REPORT OF THE CHIEF OFFICER PLANNING AND REGULATORY – 7th OCTOBER 2019

APPLICATION NO:
P/2019 /0582

LOCATION:
BROAD OAK FARM LLYNDR LANE
ROSSETT WREXHAM
LL12 0AU

DESCRIPTION:
TWO-STOREY EXTENSION AND
ERECTION OF GARAGE / CAR PORT

Proposed Rear Elevation

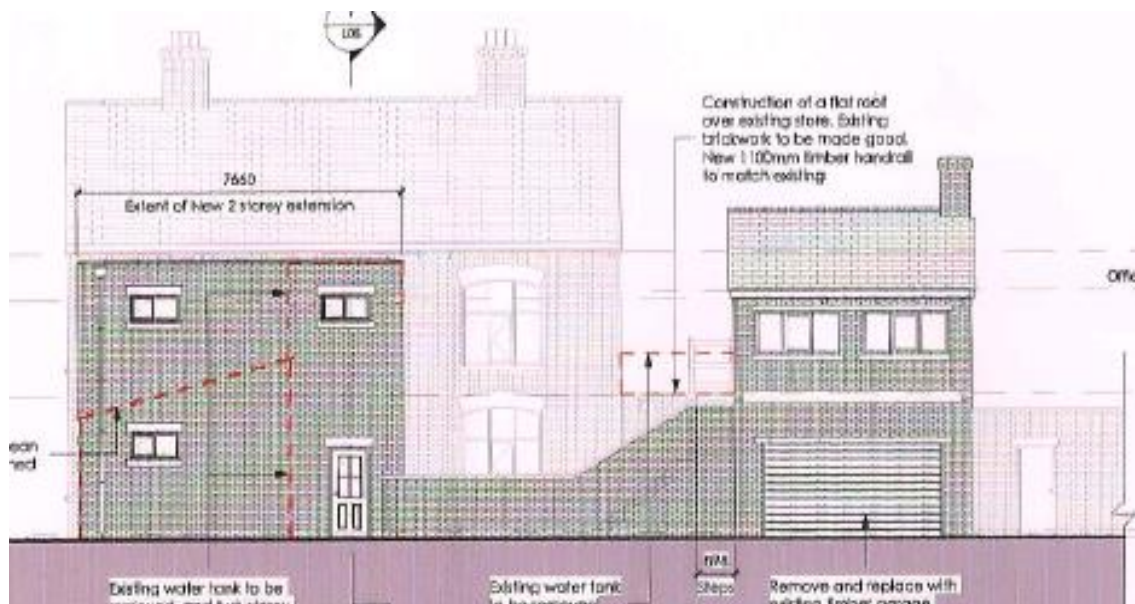
The extension would not emulate the character or quality of the existing building and would appear as an incongruous addition.

The flat roofed design, under sized window proportions, disproportionate solid to void ratio, in addition to a lack of architectural detail, is considered would fail to respond to the design and appearance of the existing building. The proposal would conflict with UDP Policy GDP1 and is recommended refusal on this basis.
